5DX-81B

S E R V I C E N O T E

5DX Series 2L, 3 and 5000 Systems

5DX Digital I/O Inspection Instructions for potentially PCA shorts

Photo 4 (Good DB9 Connectors)

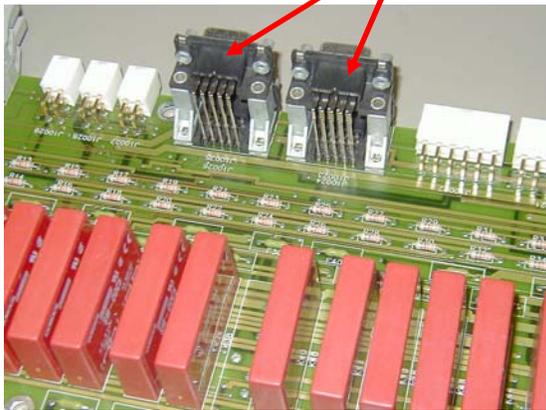
Once the panel cover has been removed, visually inspect the DB9 connectors in the back of the Digital I/O box (Connectors J10025 –J10028). See Photo 4 and Photo 5

Photo 5
(Defective DB9 Connectors if no Kapton tape underneath)

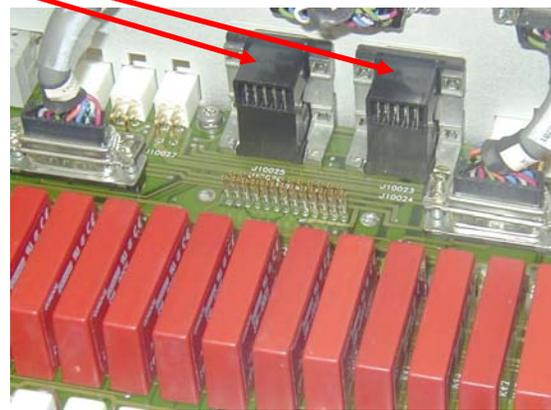
Any N7200-60079 and N7200-69079 (Digital I/Os) with the black AMP DB9 connectors Photo 6 and without Kapton tape underneath are defective and should be replaced by Agilent Qualified Personnel. The defective material should be returned to SPD.

Photo 7

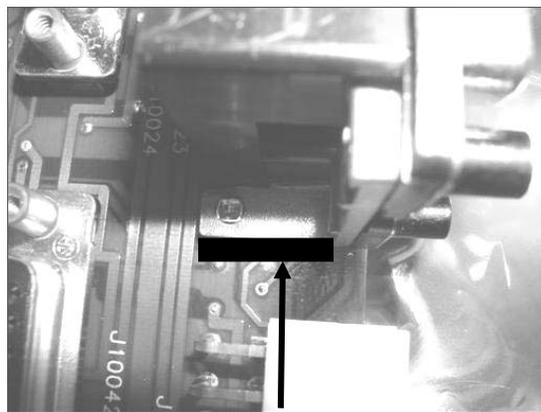
Note: Photo 7 shows the factory fix. The factory has added Kapton tape underneath the black connectors.

Photo 8

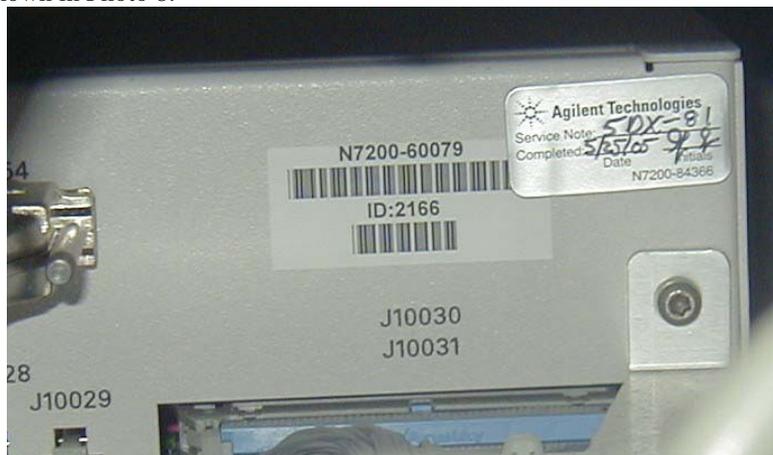
If the N7200-60079 or N7200-69079 (Digital I/O) has the correct DB9 connectors place a Service Note label on the Digital I/O as shown in Photo 8.
